Doran Drive Plaza Precinct

29/07/2022

IPC
Presentation

Amended Building Envelope

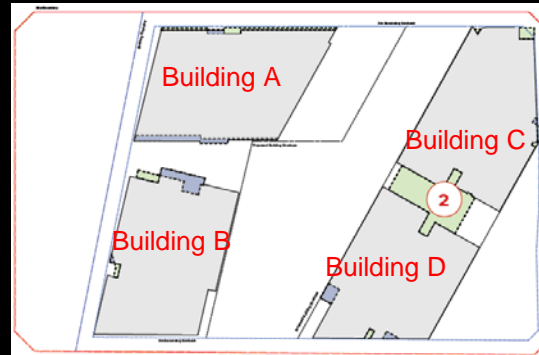
Concern Raised by SDRP and DoP

1) Removed two floors from building A

2) Removed seven floors from building C & D

Matter Closed On **24 April 2022**
By a detailed submission prepared by Turner

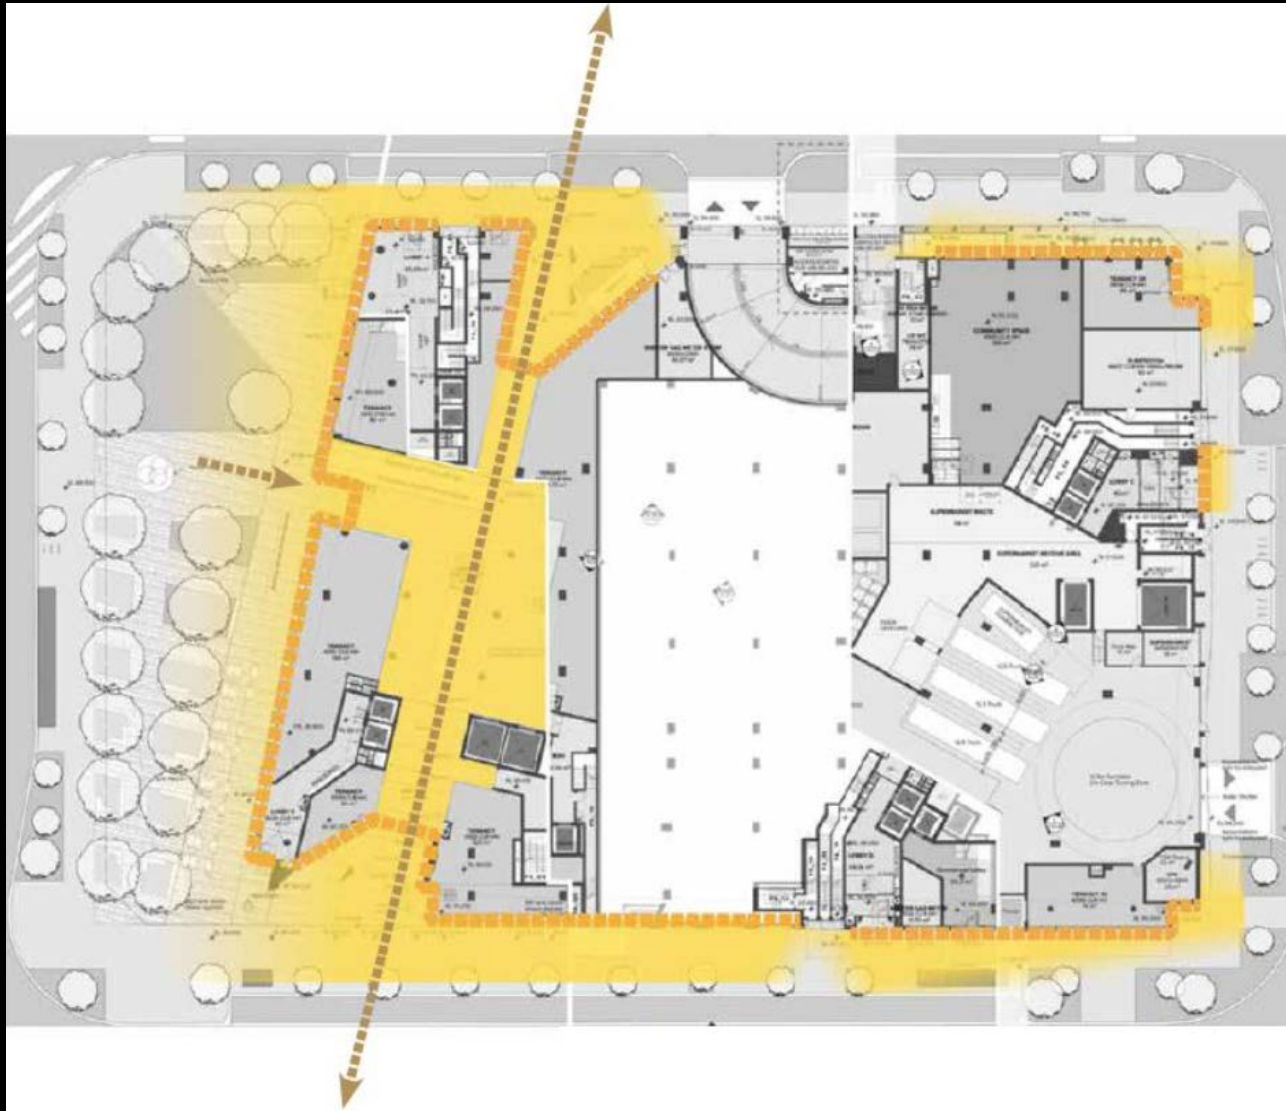
SDRP supports the separation of podium and tower forms with towers set back to ensure a suitably scaled street edge at all frontages.

Panel supports the broad range of materials and finer detailing on the podium frontages.

(SDRP Session – 30.3.2022 - fourth review)

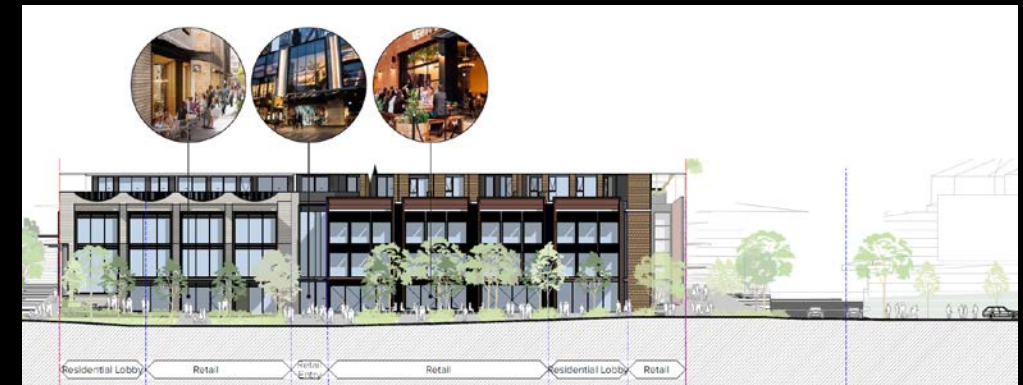
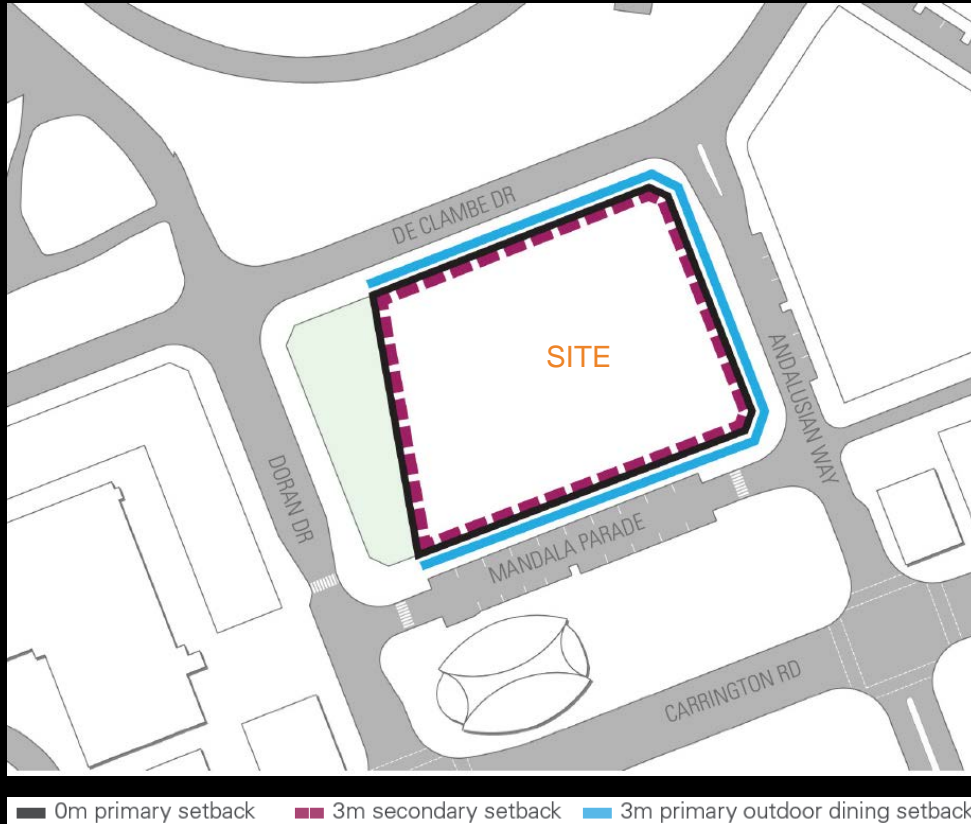
Matter Closed On **10 November 2021**
Concern was raised in SDRP session review 1 & 2, and was discarded from the subsequent meeting minutes

Clear sight-lines and circulation from Mandala Parade to De Clambe Drive

Yellow indicates activated facade

Figure 1 - Approved building separation (Source: Concept Approval UDG)

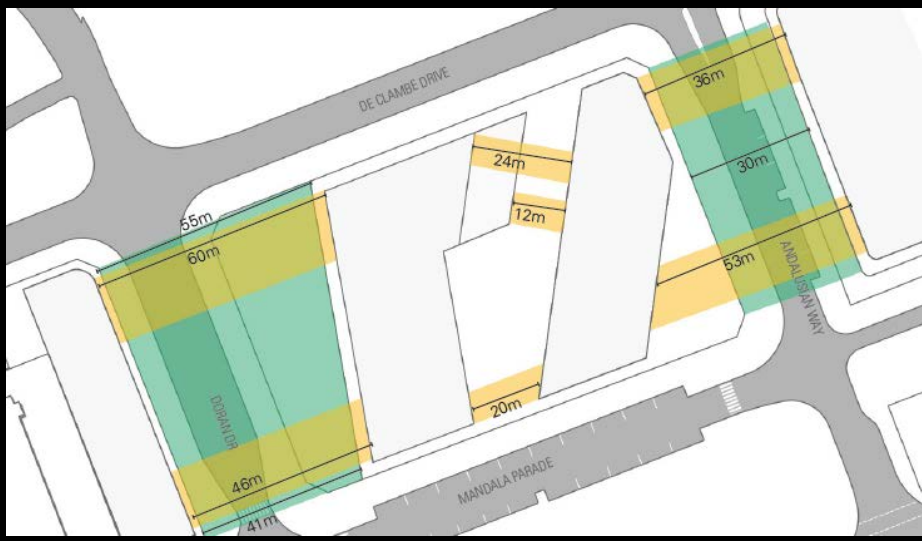
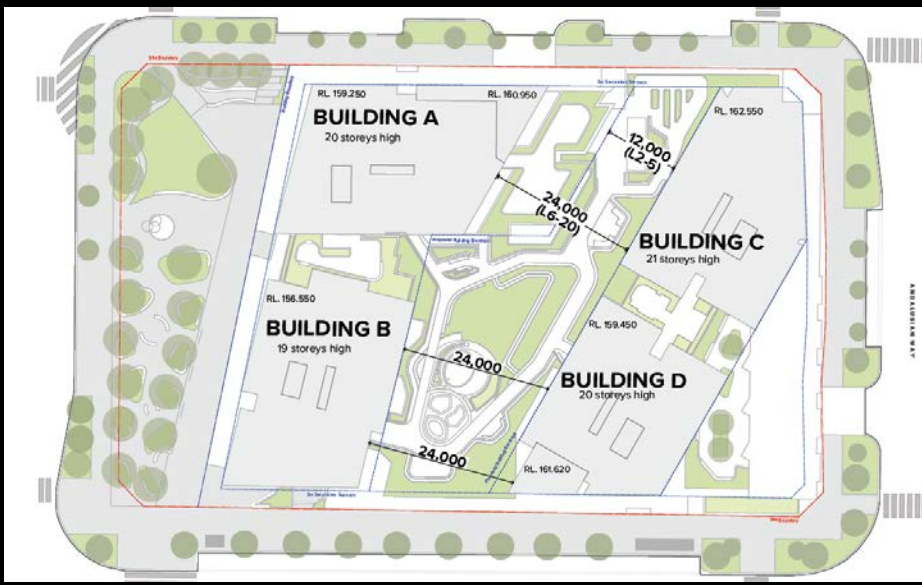
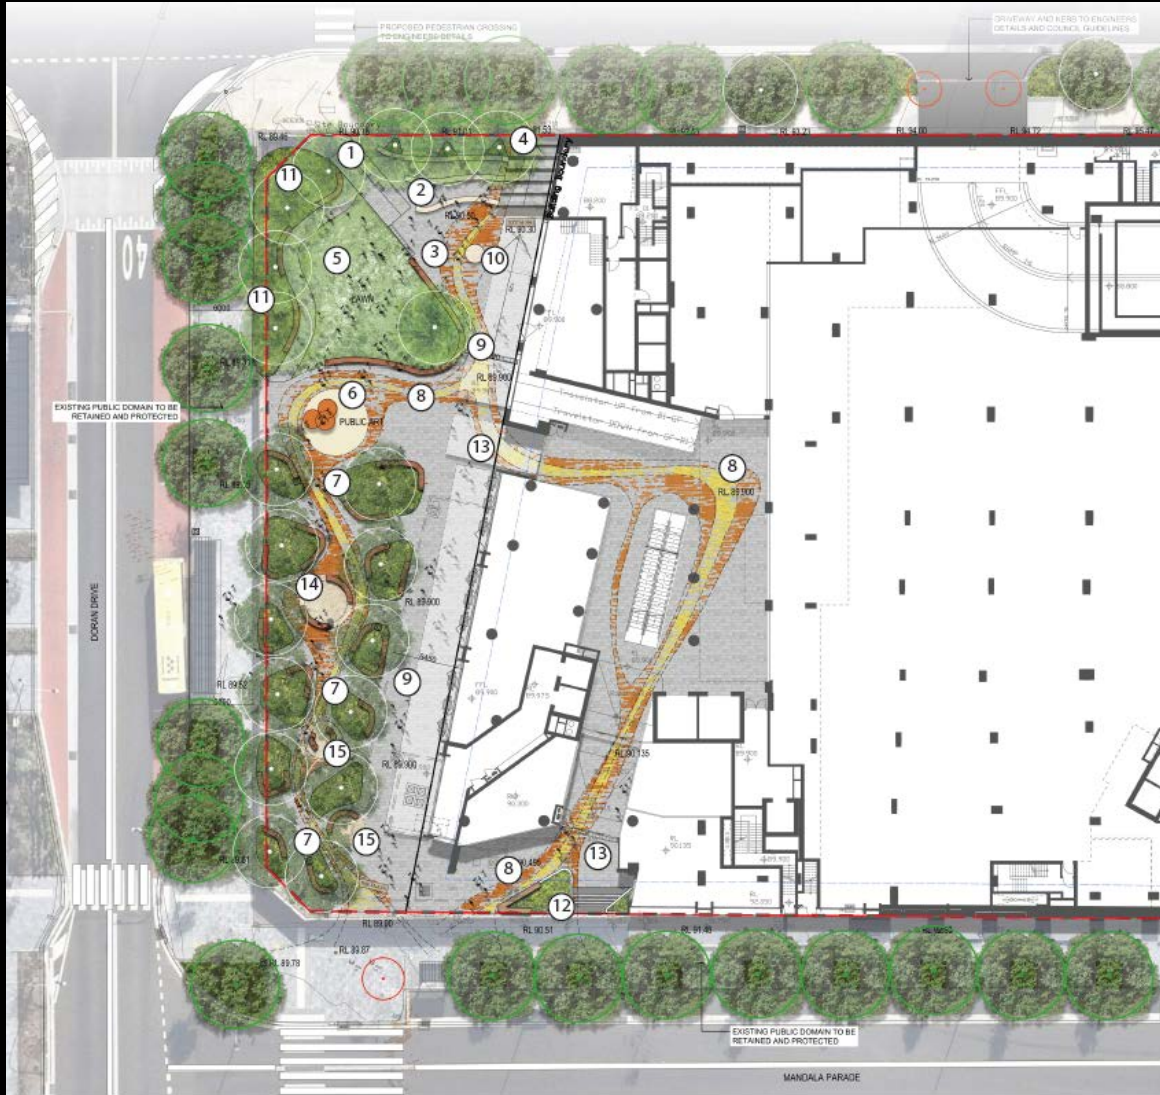
Matter Closed On **20 May 2022**
By a detailed submission prepared by Turner

- Proposed development complies with the minimum separation of 12m and 24m between the towers on the northern interface and 20m between the towers on the southern interface.
- Proposed development complies with the separation between building envelopes within Precinct West and Precinct East.

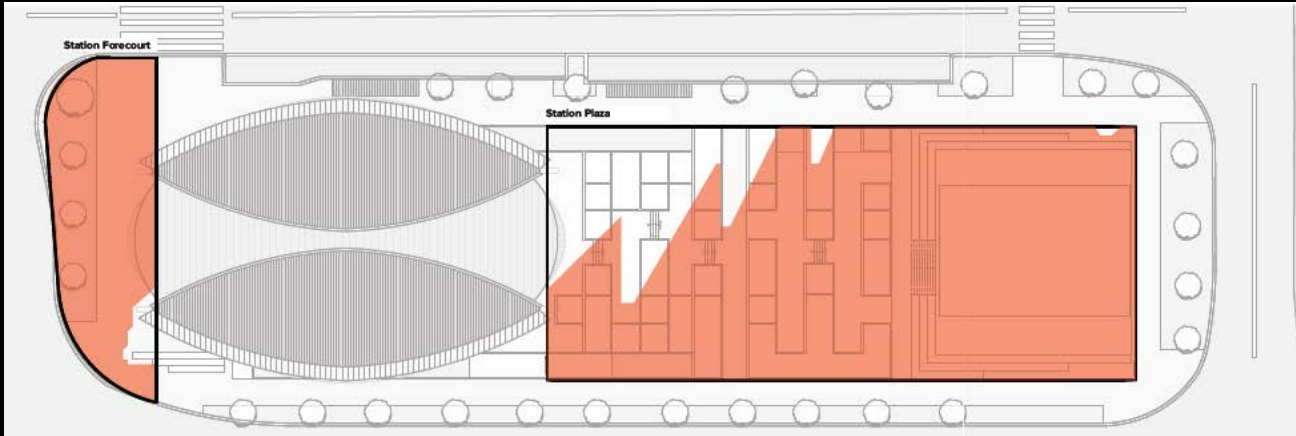
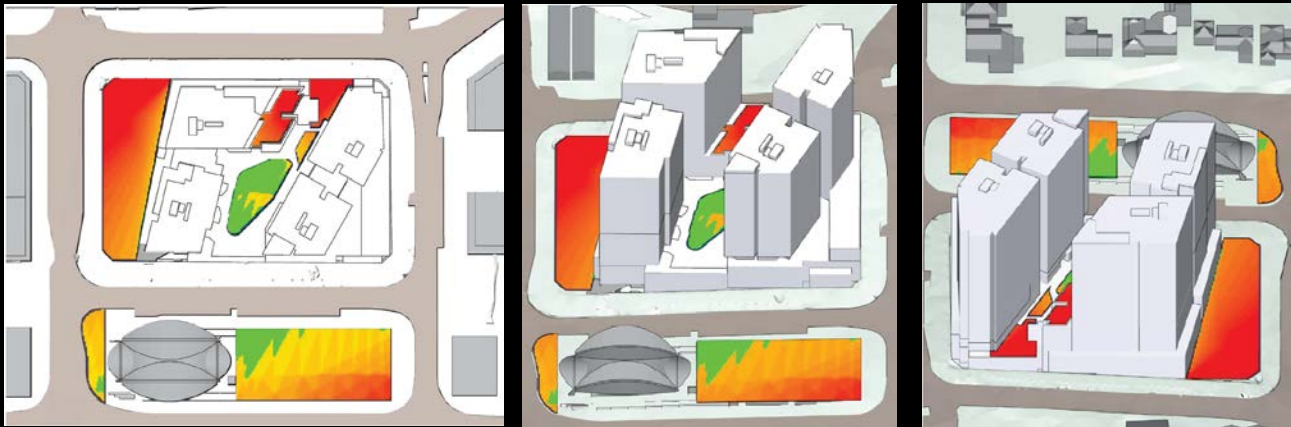
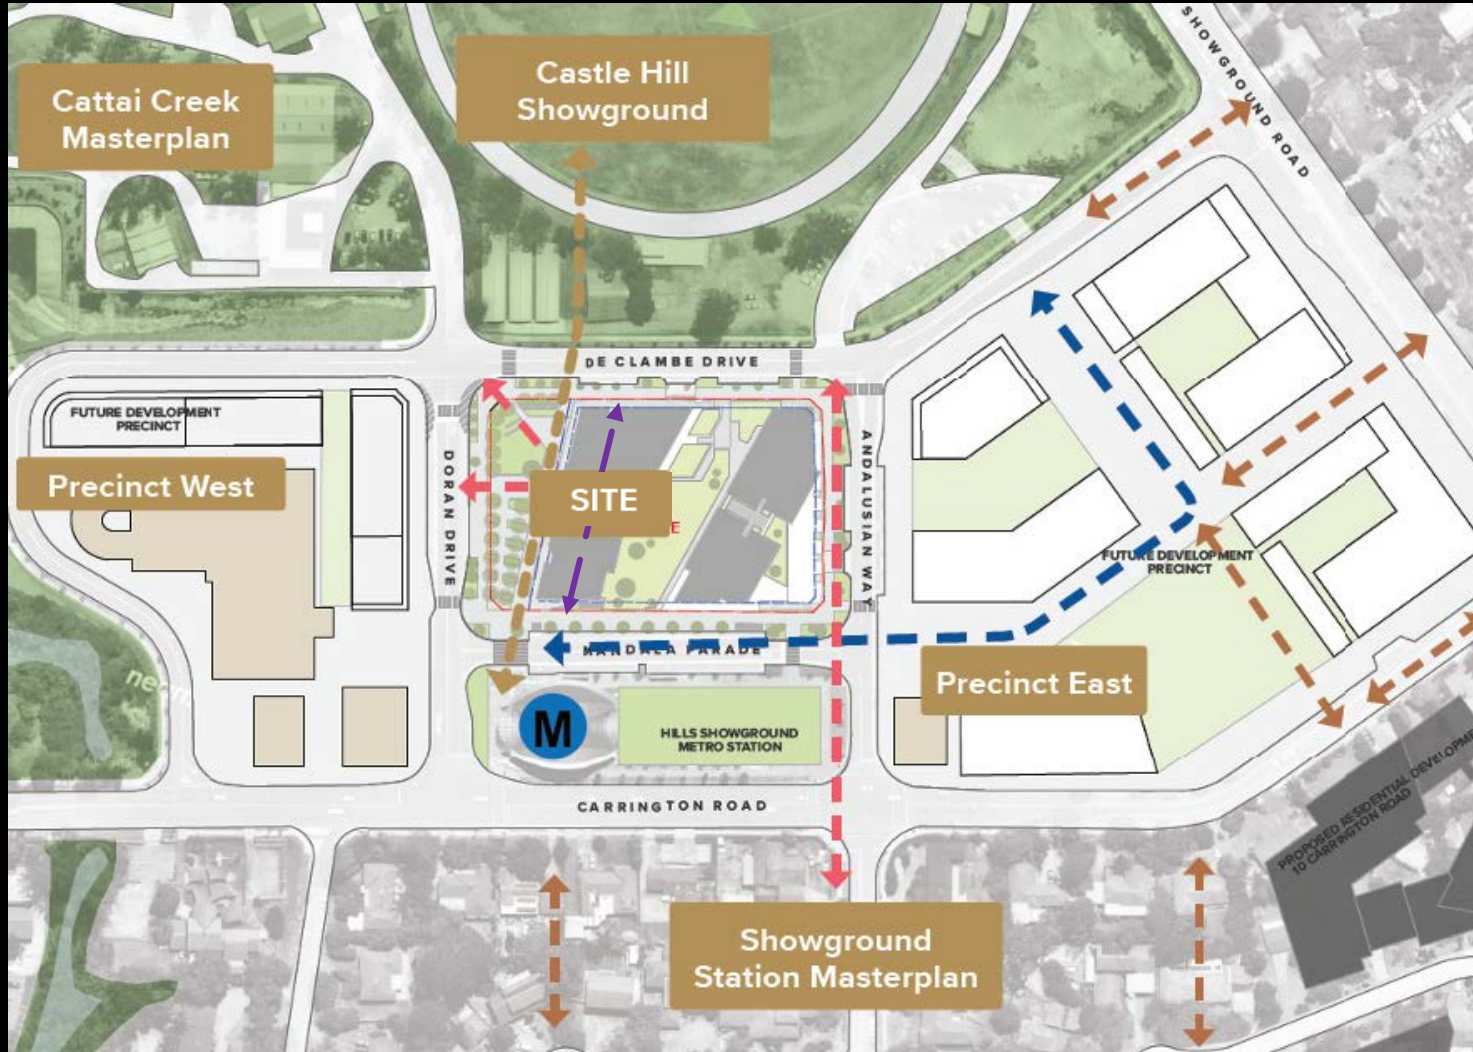
Matter Closed By **20 May 2022**
By a detailed submission prepared by Turner

- **Station Plaza** (65% solar access required)
 - Total Measured area = 1800 sqm
 - Total measured area achieving >2hrs = 1500 sqm = **83.3%**

- **Station Forecourt** (80% solar access required)
 - Total Measured area = 385 sqm
 - Total measured area achieving >2hrs = 360 sqm = **93.5%**

- **Doran Drive Plaza** (100% solar access required, excluding area under awnings)
 - Total Measured area = 1400 sqm
 - Total measured area achieving >2hrs = 1400 sqm = **100%**

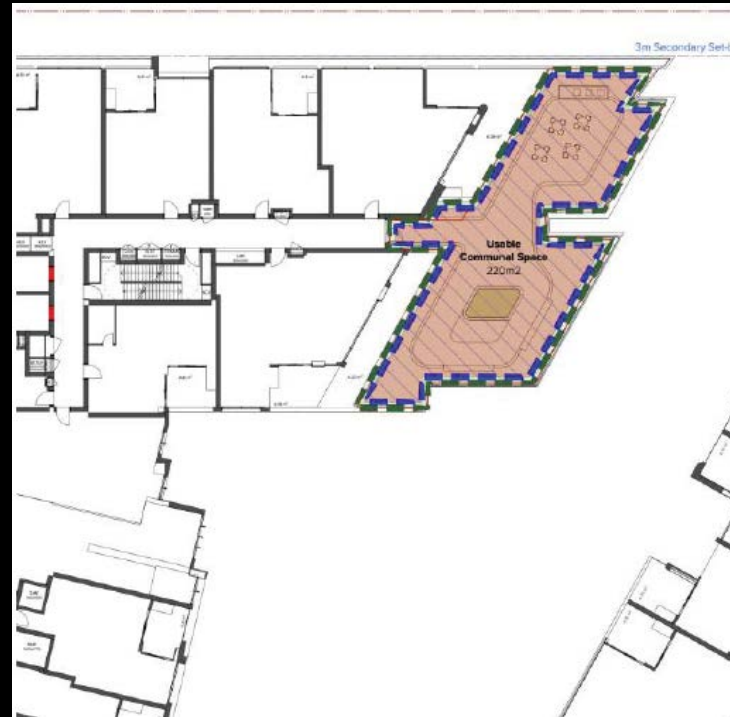
Concern Raised By **SDRP**

SDRP commented:

To ensure soil depths and solar access conditions are sufficient to support growth for the tree species selected. (SDRP Session – 30.3.2022 – fourth review)

Matter Closed On **24 April 2022**
By A detailed response prepared by Turner

ADG Objectives - Developments achieve a minimum of 50% direct sunlight to the principal usable part of the communal open space for a minimum of 2 hours between 9am and 3pm June (mid Winter) Total Measured area = 1800 sqm

- **Primary Open Space** = 865 sqm
- **Primary Open space > 2 hrs** = 523 sqm
= **60.5%**
